**CITY OF WEST DES MOINES
STAFF REPORT COMMUNICATION**

Meeting Date: March 27, 2023

ITEM: Primrose School, 8080 Coachlight Drive – Approve a Preliminary Plat to create 2 lots for Commercial development and Approve a Site Plan to allow construction of a daycare building – Hurd Parkway, LLC – PPSP-005889-2022

SITE PLAN

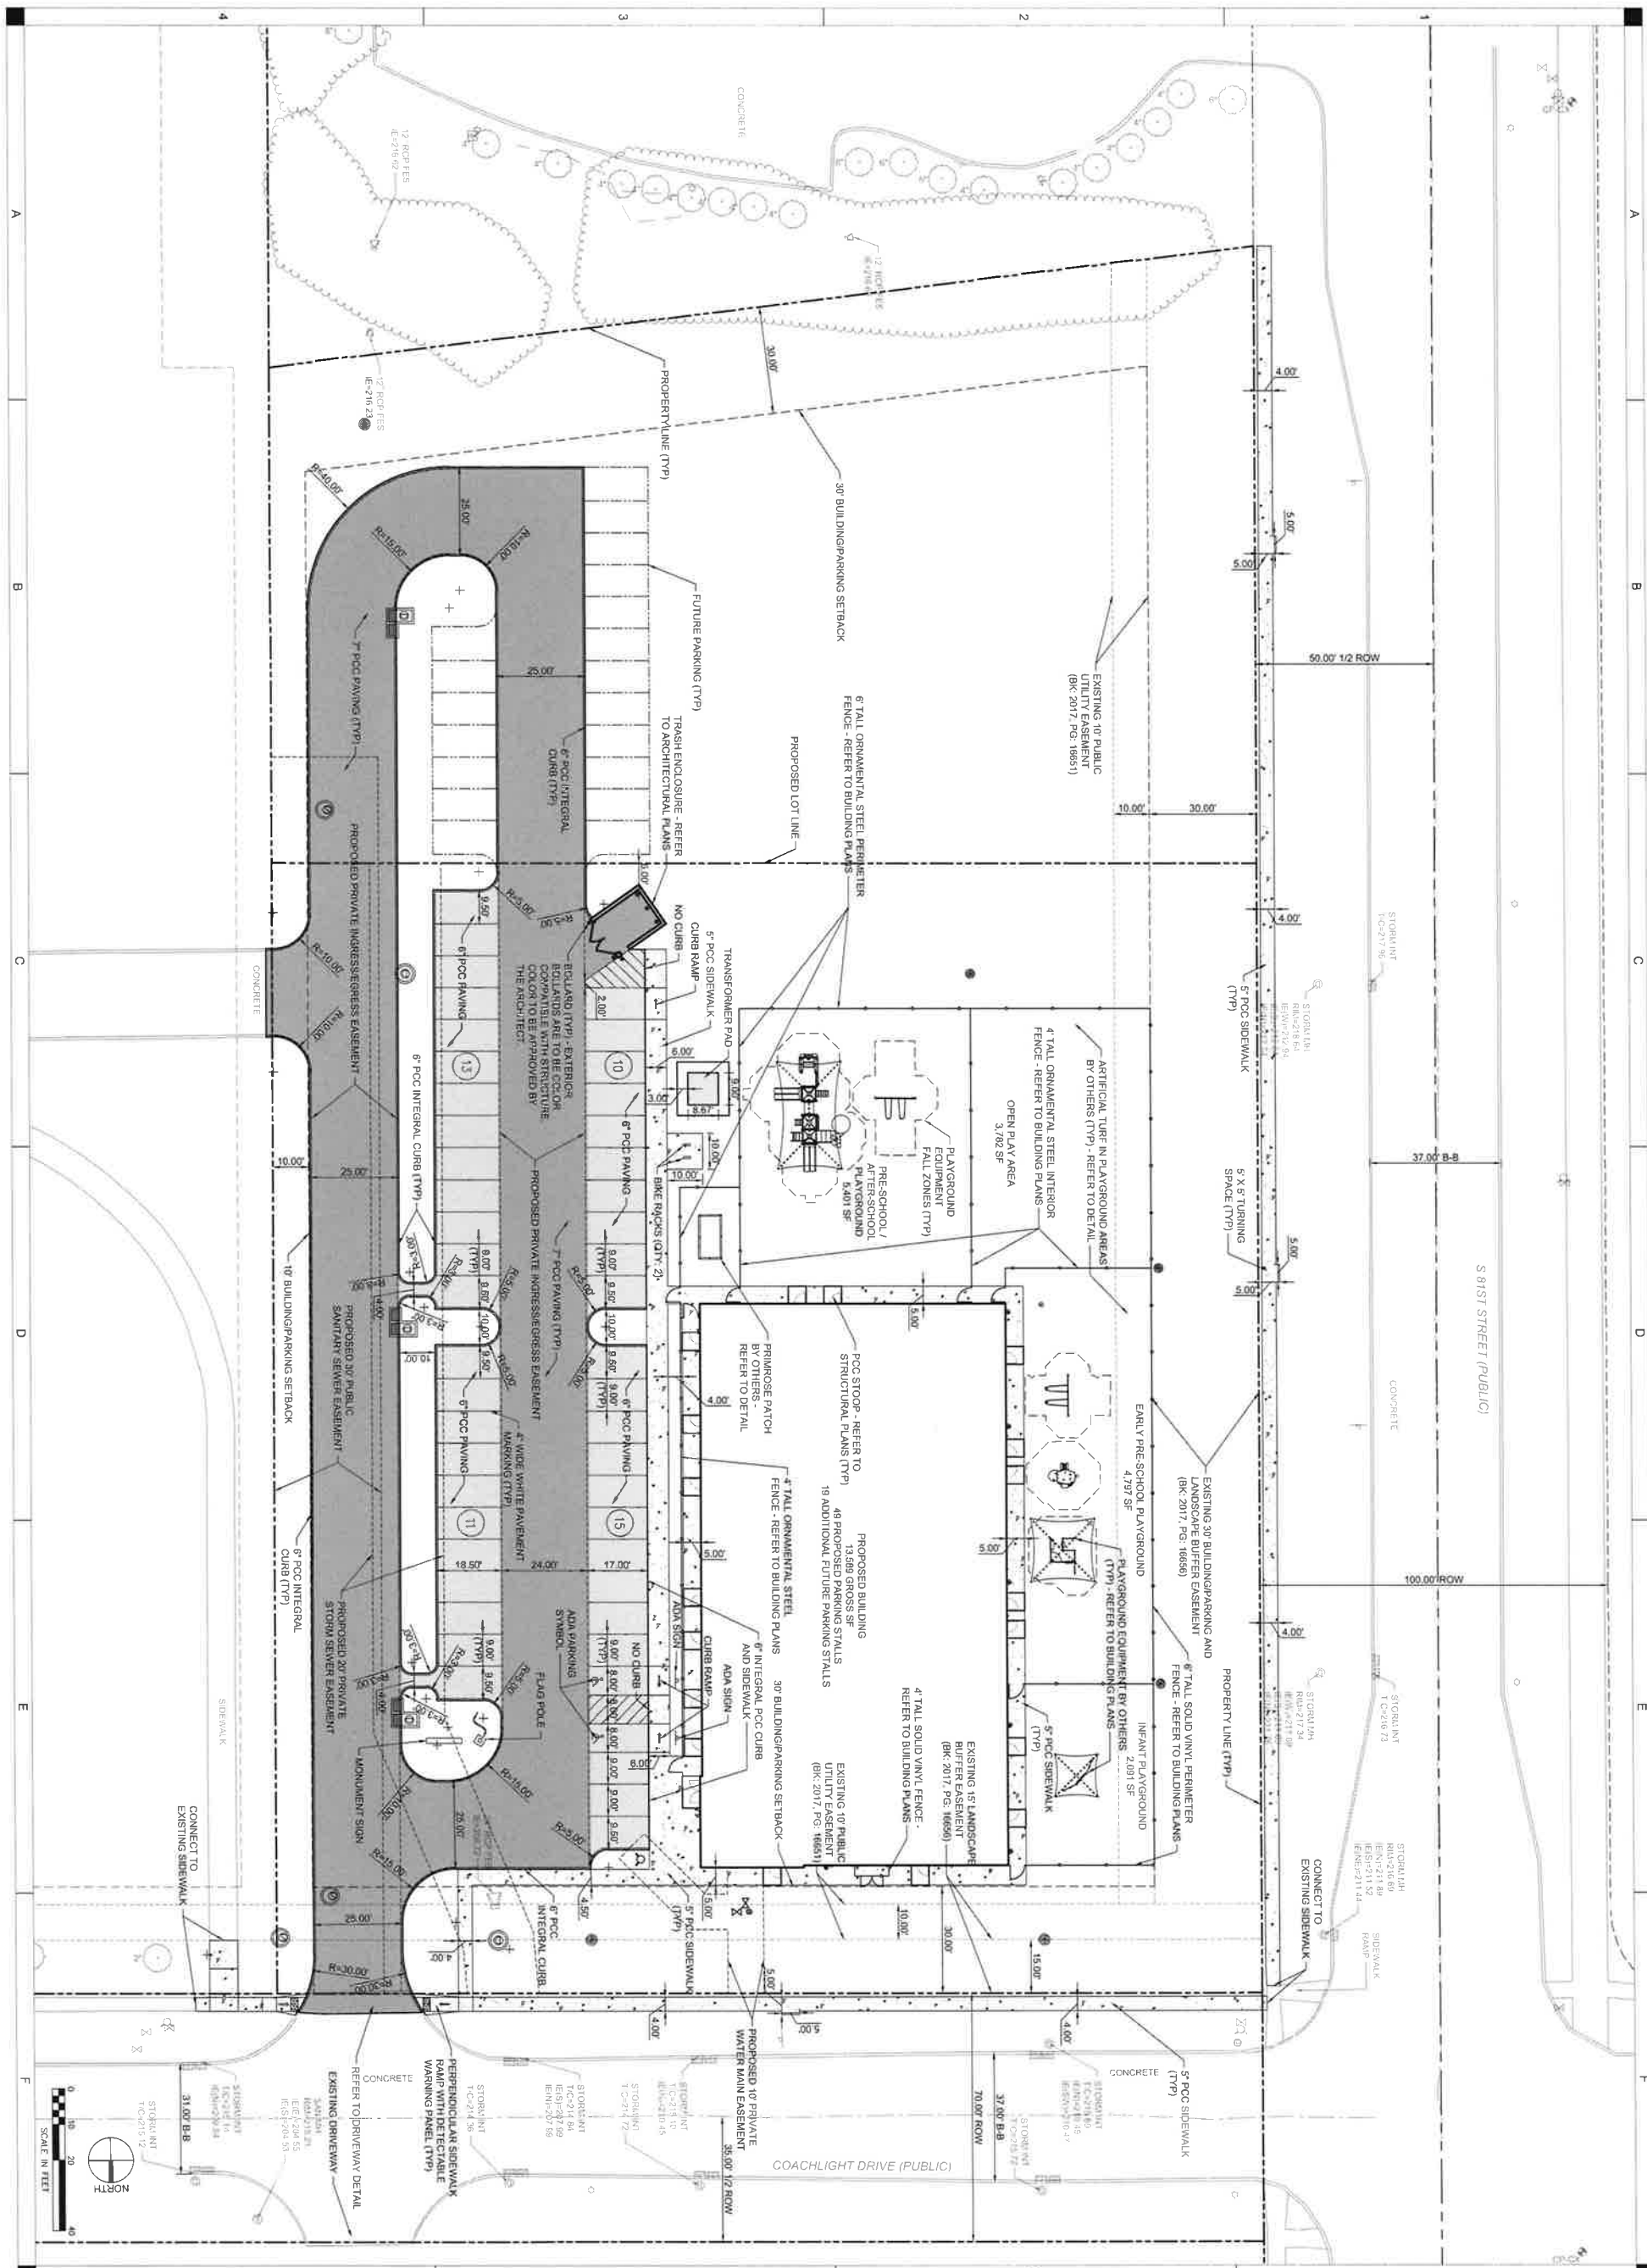
- **Key Development Aspects:**
 1. **Parking:** According to City Code, the number of parking spaces required for a daycare is 3 spaces per 1,000 square feet of building gross floor area (GFA) plus 1 space per employee. The proposed building will be approximately 13,590 square feet and there will be a maximum of 34 employees on site. Based on the building size, 41 spaces are required, plus 1 space per employee (34 spaces) which equates to a total of 75 parking spaces required by City Code for the day care use. The applicant has provided a parking analysis that was completed at four existing Primrose daycare facilities showing that their peak parking demand is around 30 parking spaces and generally occurs around 8:30 AM each weekday. The applicant is proposing to construct 49 parking spaces on the site and has identified where an additional 19 spaces could be located if needed in the future (shared with the proposed lot 2 to the south). A shared parking agreement has been provided to allow for shared parking between the two lots. Based on this information, staff feels that the proposed 49 parking spaces to be constructed will be more than adequate for this use. City Code states: *The City Council reserves the right to waive or modify to a lesser restriction any provision or requirement of off-street parking and loading areas contained in this chapter, provided said waiver or modification does not adversely affect the intent of these regulations to adequately safeguard the general public and surrounding property.* Therefore, Staff recommends a condition of approval allowing for a deferral of the 19 shared parking spaces and a waiver of an additional 7 spaces to comply with the 75 spaces required by City Code.

1. The City Council accepting the parking needs and parking analysis study of existing Primrose sites provided by the applicant and approving the waiver of the installation of 7 parking spaces.

2. The City Council deferring the installation of 19 parking spaces until such time that on-site events in which parking on the grass or other non-designated parking areas occurs due to the lack of available parking stalls. At the time when the existing parking is not sufficient to accommodate the facility's operations, the City reserves the right to provide the applicant notice to increase the number of parking stalls. The applicant will be required to provide at least the additional 19 parking spaces in accordance with City regulations within the first available construction season. Prior to implementation of additional parking to satisfy the deferred parking stalls, the applicant shall submit for approval a Site Plan Application to the City identifying the location and engineering details for the stalls to be constructed.
